REDLAND OAKS SUBDIVISION
PRELIMINARY OVERALL AREA DEVELOPMENT PLAN

☐ Preliminary Plan
Re: Redland Oaks (Sitterle) ☒ P.O.A.D.P.
File #: 84-17-63-88

Because the relationship of the proposed Redland Road alignment depicted on your plan and the Windchase P.O.A.D.P. (File #84-18-63-08) are conflicting, staff cannot comment at this time. As mentioned to you, on September 21, 1984 staff met with Sitterle and Mann representatives to discuss available alignment alternatives to satisfy major thoroughfare plan requirements. Based on this and subsequent discussions, it is our understanding that there is still an on-going effort to resolve the matter. Therefore, staff review of both your plan and the Windchase plan is being held in abeyance pending resolution of this matter.

redland oaks

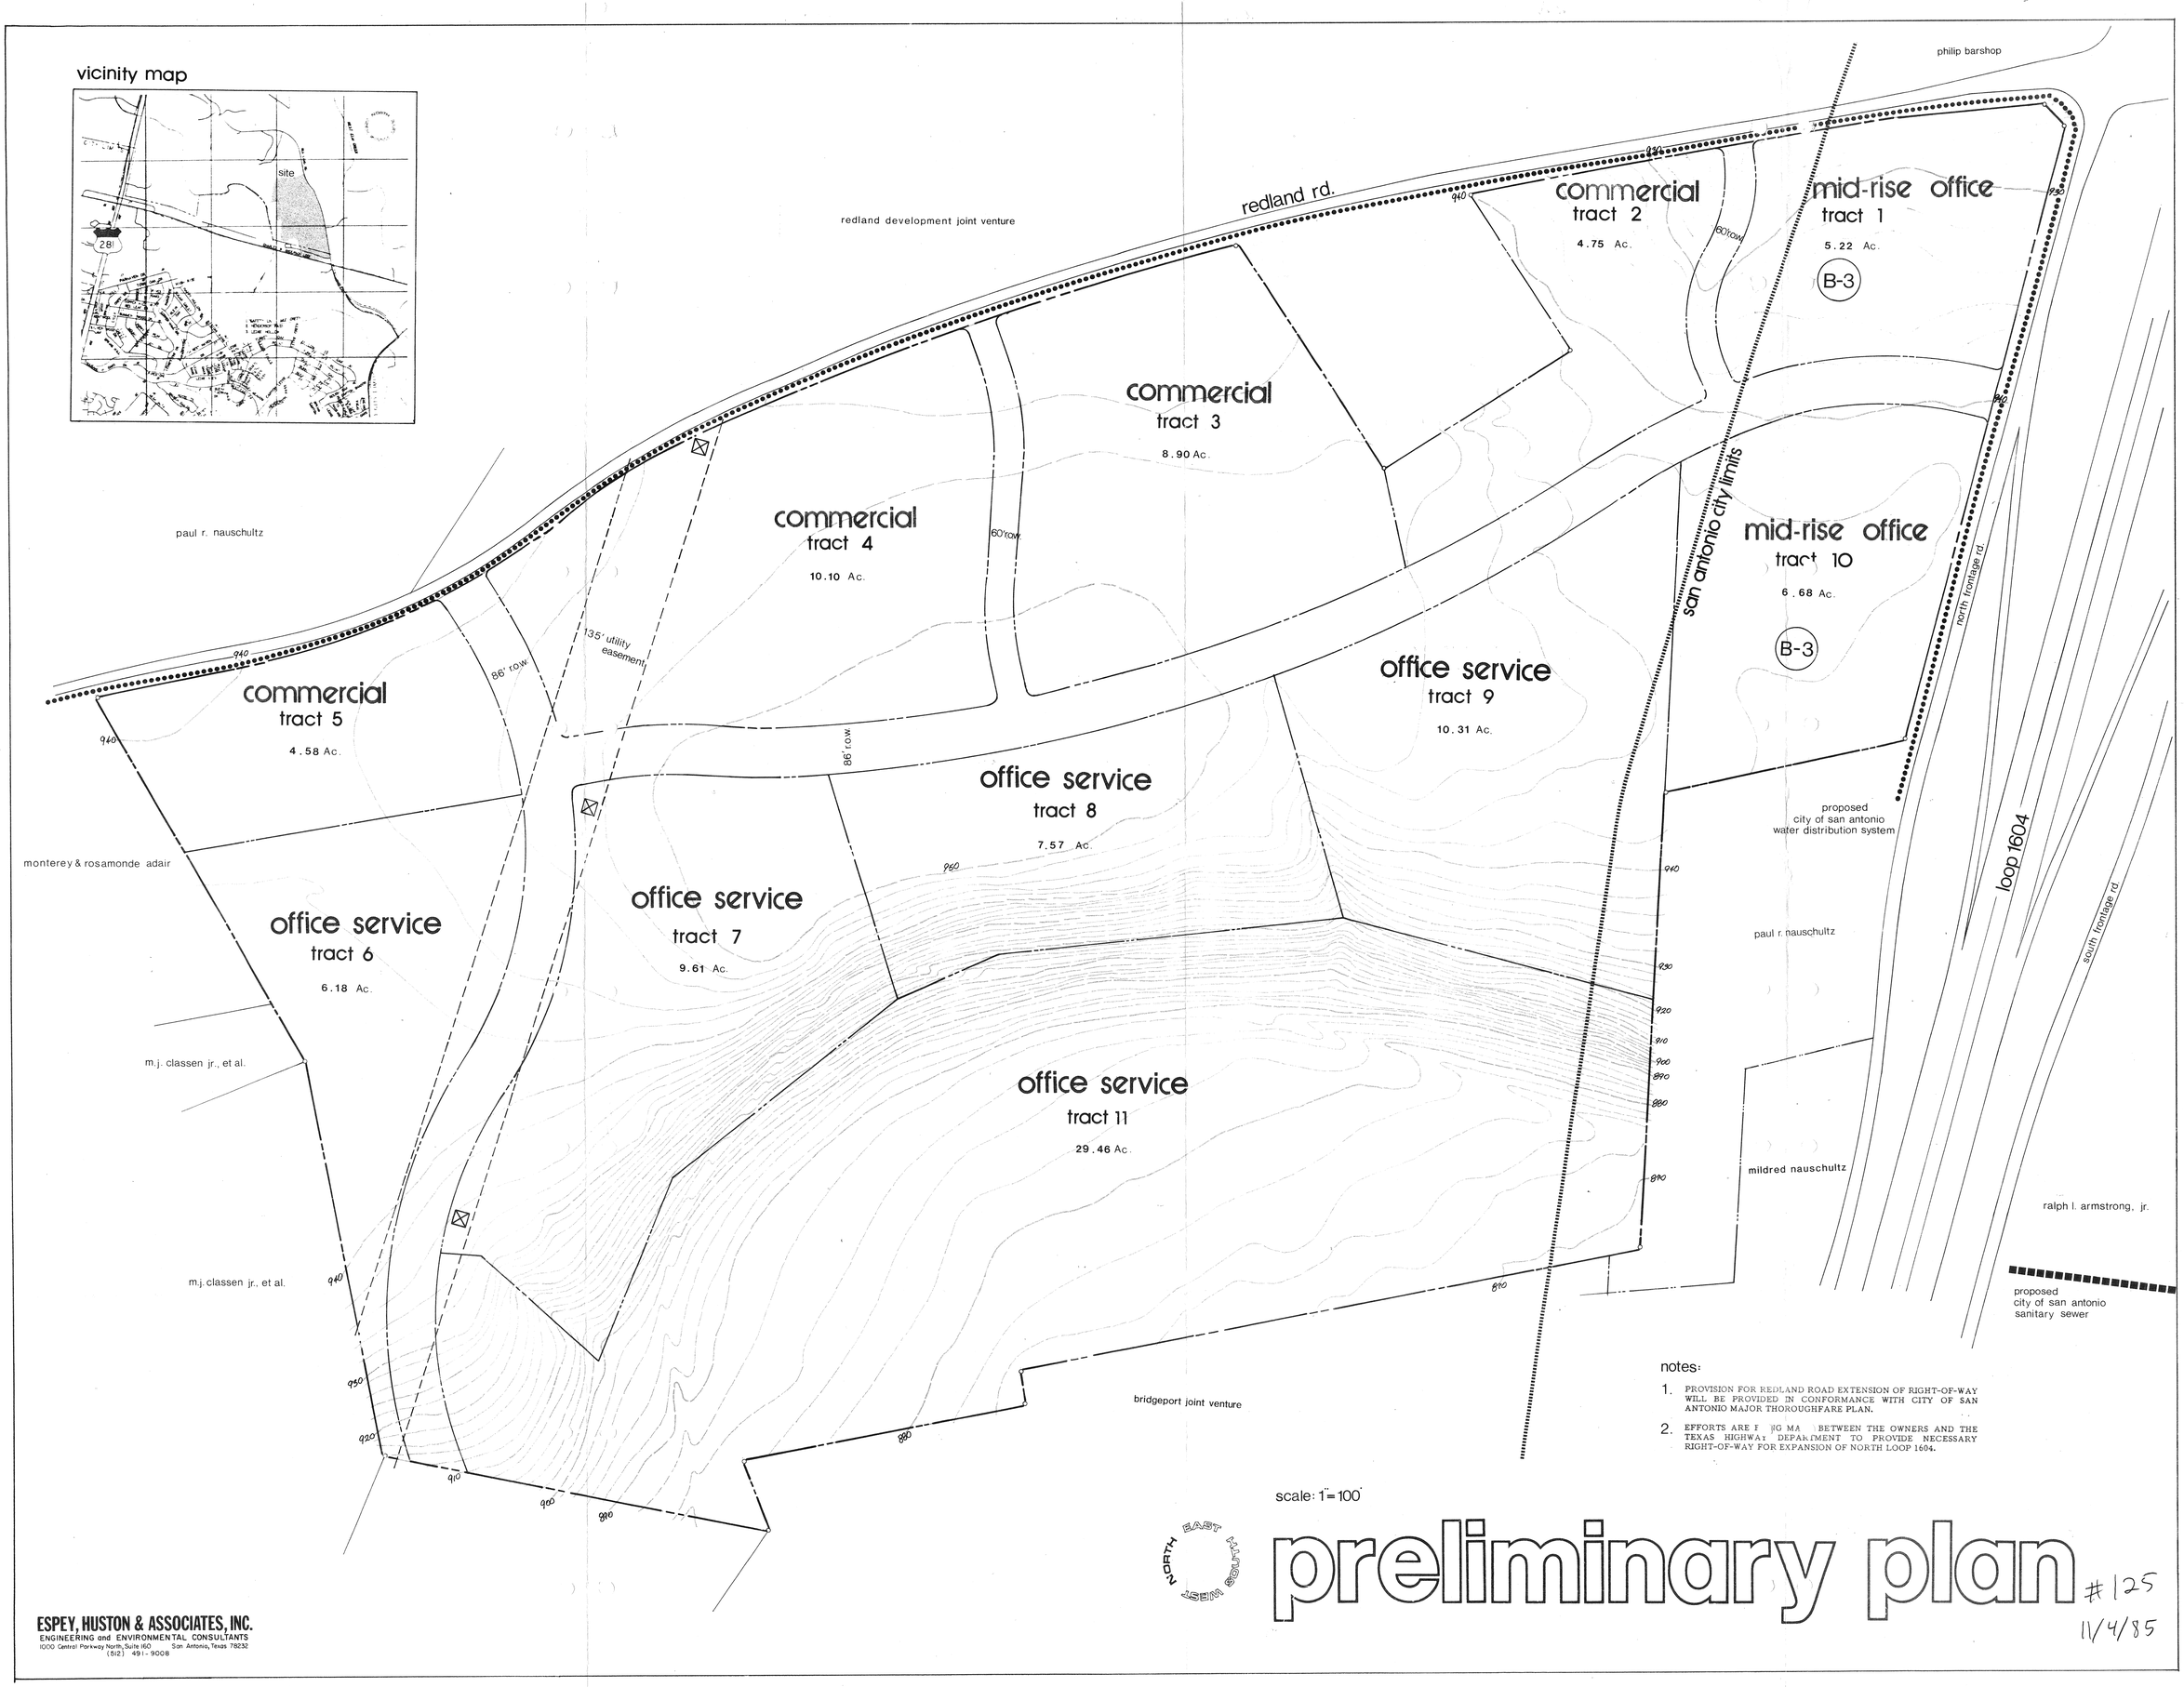
Redland Road is a Secondary Arterial Type "A", 86' R.O.W. on the Major Thoroughfare Plan. Provisions for proper street dedication is requested. Please revise your plan accordingly.

1. PROVISION FOR REDLAND ROAD EXTENSION OF RIGHT-OF-WAY WILL BE PROVIDED IN CONFORMANCE WITH CITY OF SAN ANTONIO MAJOR THOROUGHFARE PLAN.
2. EFFORTS ARE F[illegible]G MA[illegible] BETWEEN THE OWNERS AND THE TEXAS HIGHWAY DEPARTMENT TO PROVIDE NECESSARY RIGHT-OF-WAY FOR EXPANSION OF NORTH LOOP 1604.

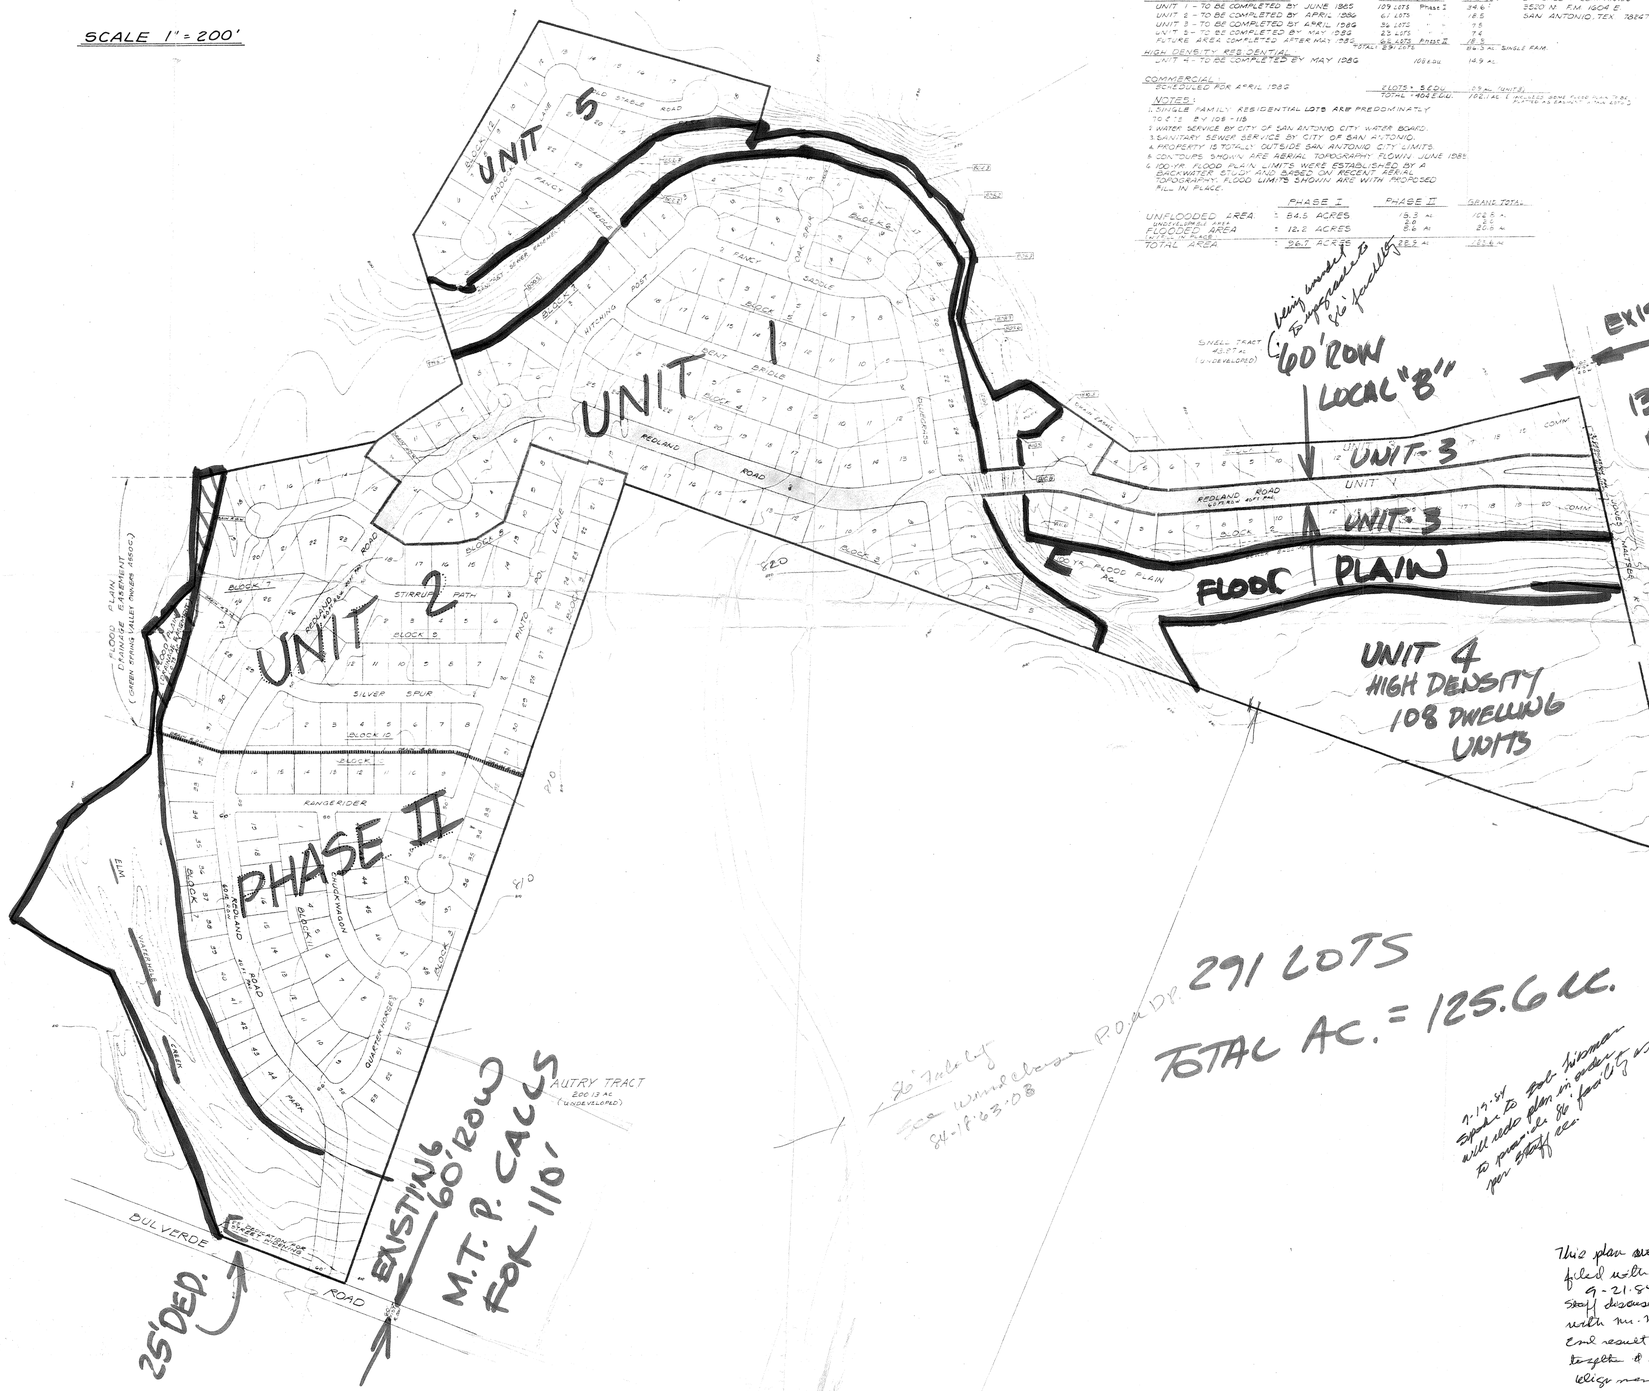
This plan was never formally filed with us.
9-21-84
Staff discussed Redland Rd. alignment with Mr. Mann (Wind Crest) & Sittele representative and result was both parties would get together & discuss alternative street align. ments.

REDLAND OAKS SUBDIVISION
PRELIMINARY OVERALL AREA DEVELOPMENT PLAN

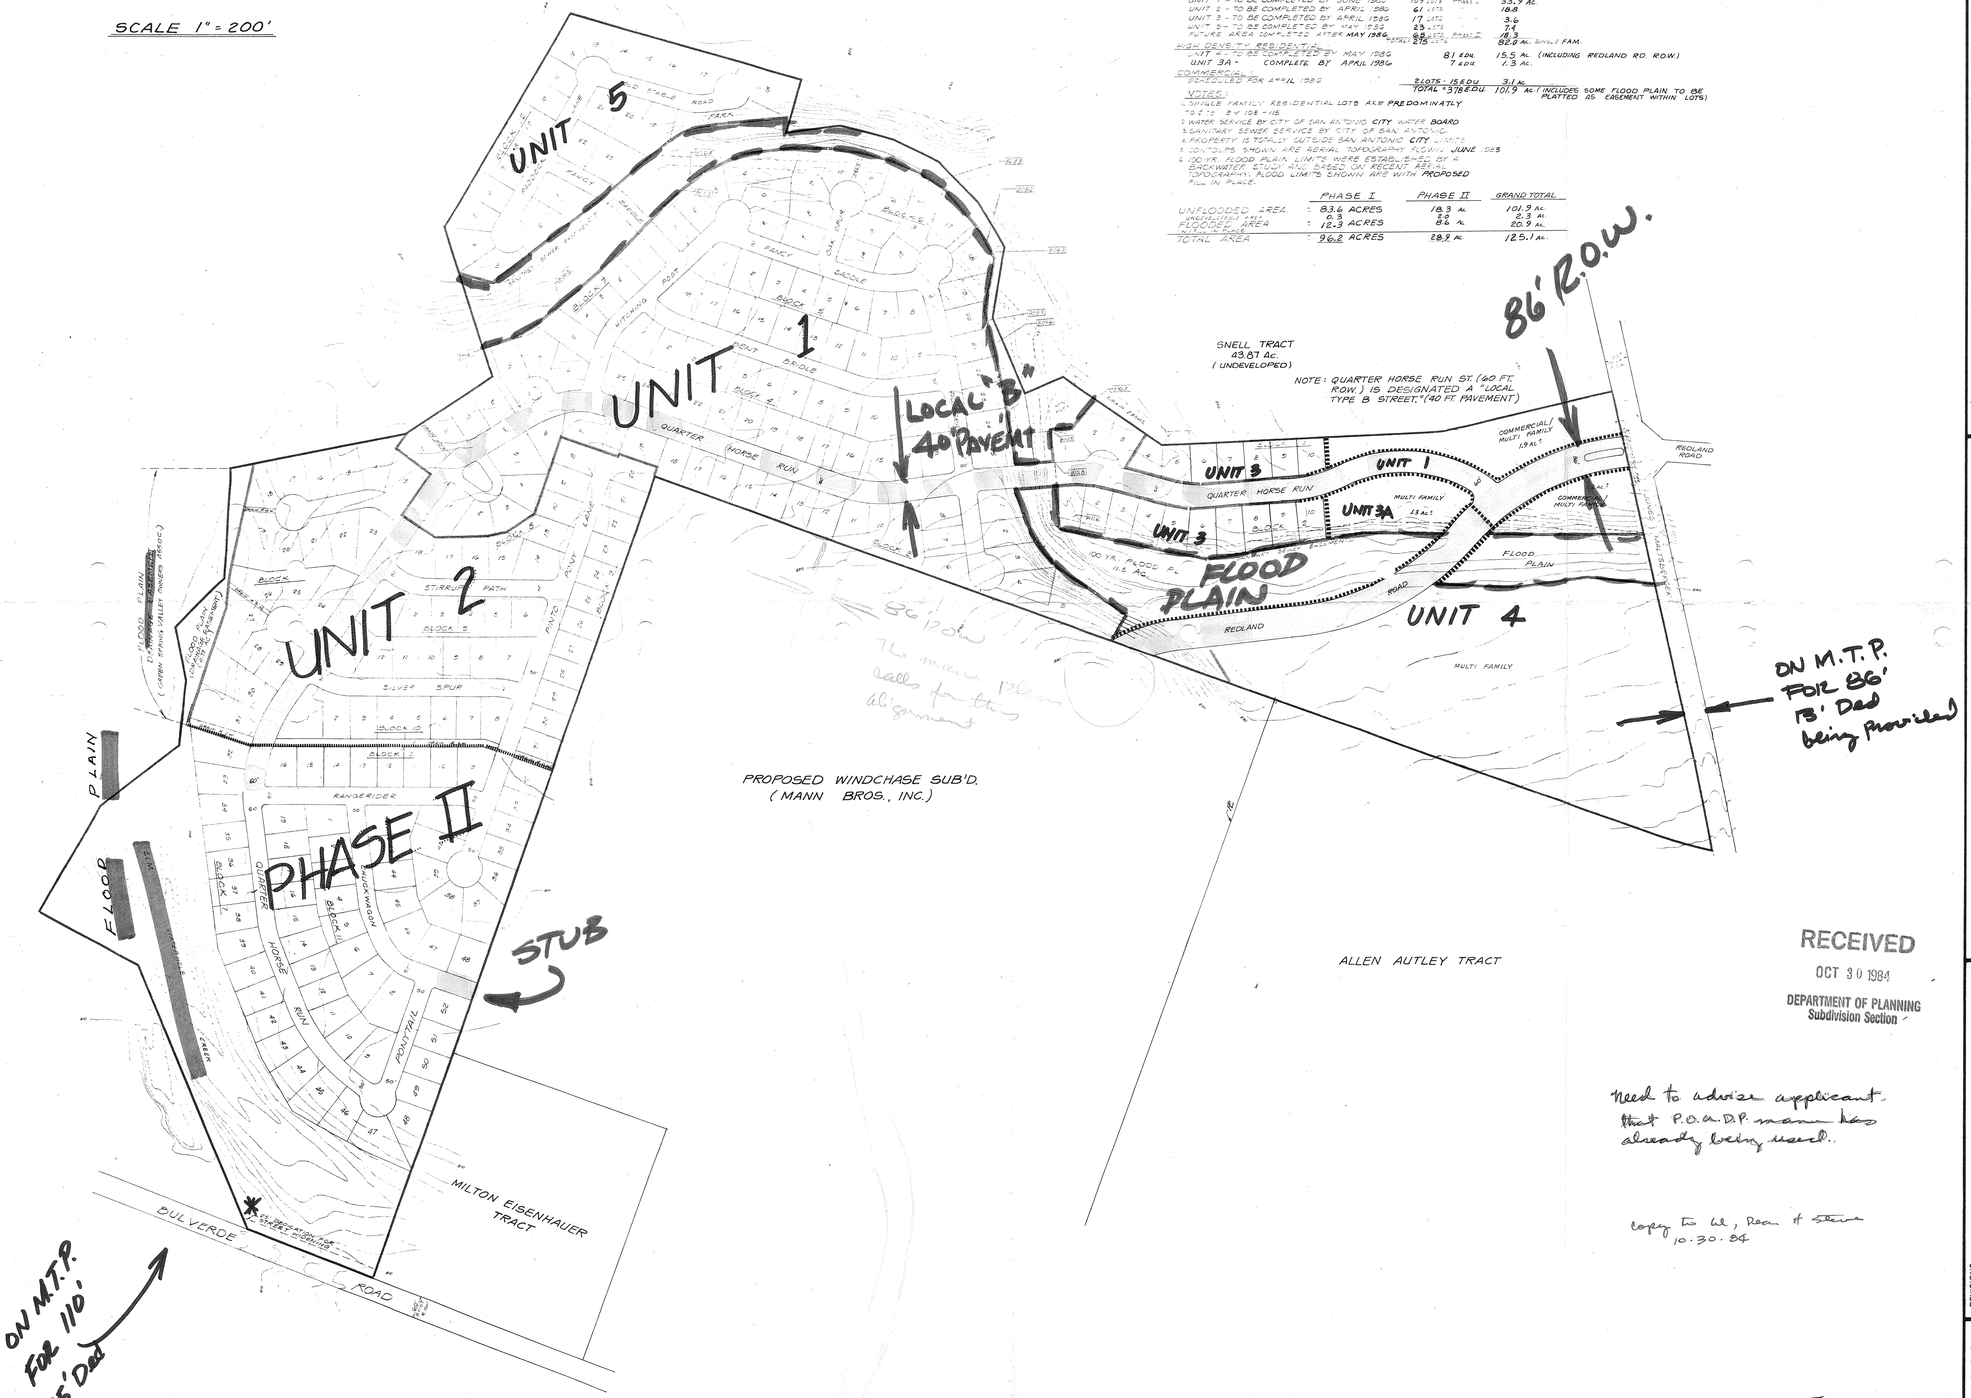
Need to advise applicant that P.O.A. D.P. mann has already being used.
